Re: 123 Wheeler St S, Ref. #111831 – Application for Appeal Addendum

This is to request consideration for the deficiencies that were included in the fire inspection correction notice.

Dryer exhaust vent:
Current transition duct length is ~79"
It connects to solid metal ductwork at the dryer and to the outside connection.

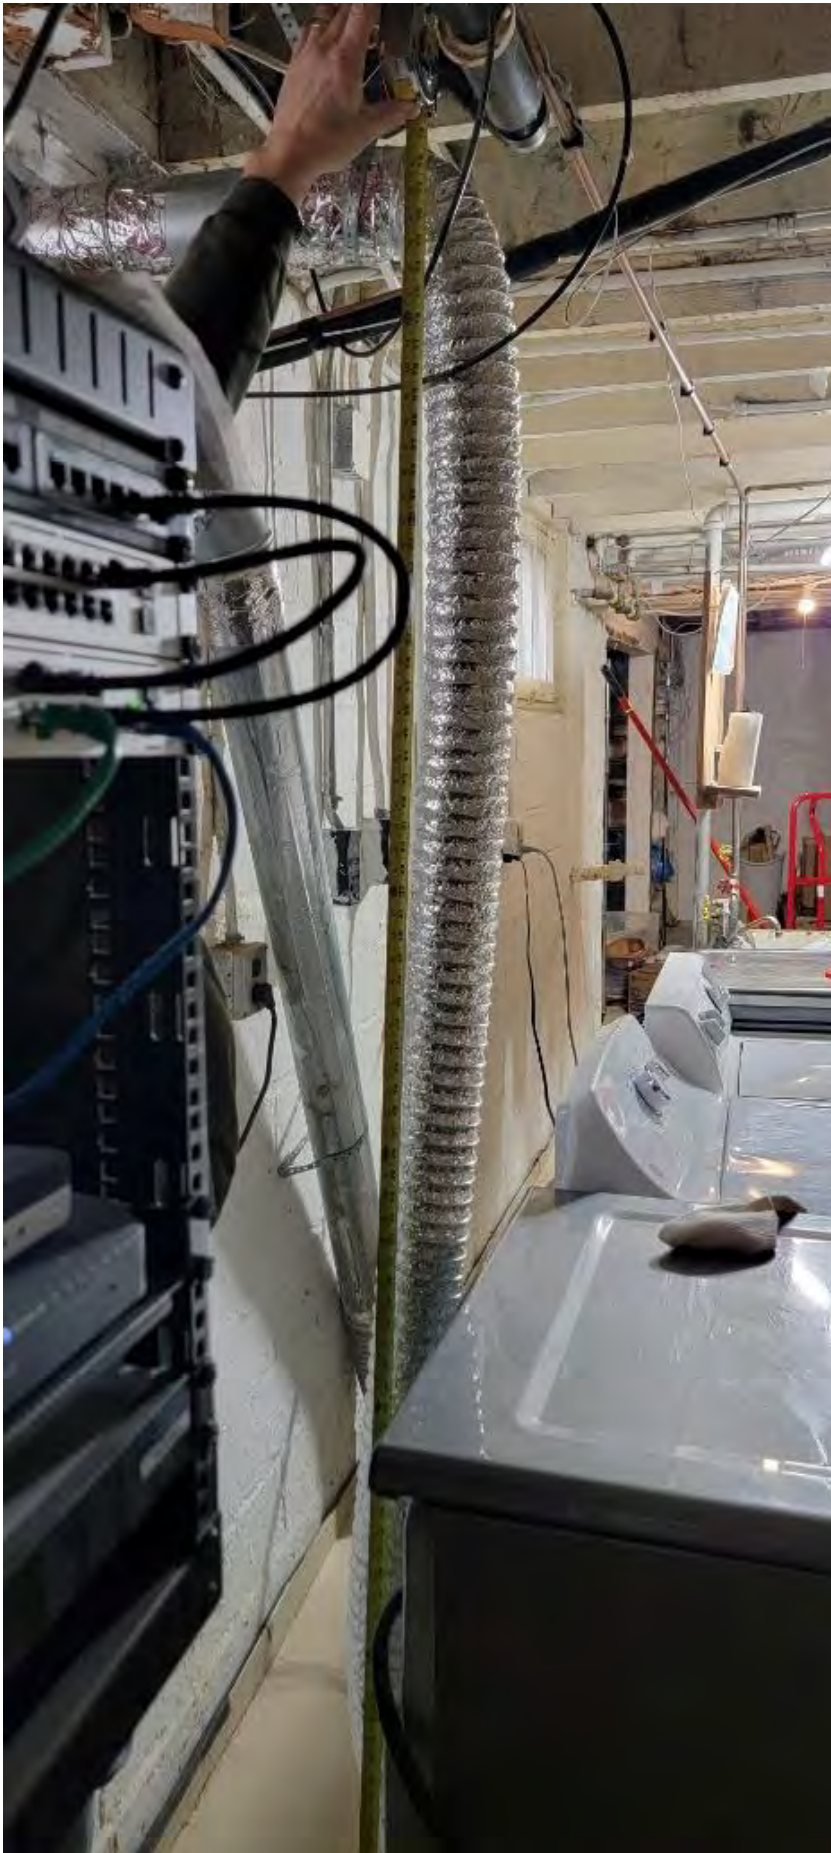
1. Dryer vent – notice states that flexible dryer vent is approx. 10 ft. Rakhma measures its current transition vent to be ~79” (see photo at end of document). The connection from the dryer as well as to the outside is solid metal and does not contain any screws. The vent is not concealed within construction. It is our understanding that code allows up to 8 ft for transition vent based upon the following (2020 Minnesota Mechanical and Fuel Gas Code 504.8.3 Transition ducts): “Transition ducts used to connect the dryer to the exhaust duct system shall be a single length that is listed and labeled in accordance with UL 2158A. Transition ducts shall be not greater than 8 feet (2438 mm) in length and shall not be concealed within construction.” (<https://www.dli.mn.gov/business/codes-and-laws/2020-minnesota-state-building-codes>) *fyi... we were unable to find the code on the City of St. Paul website.*

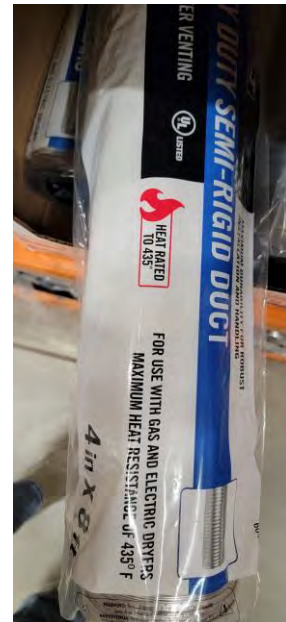
During the hearing on Tuesday, May 7, 2024 we were asked to provide the UL Listing on the material. Here is what was purchased:
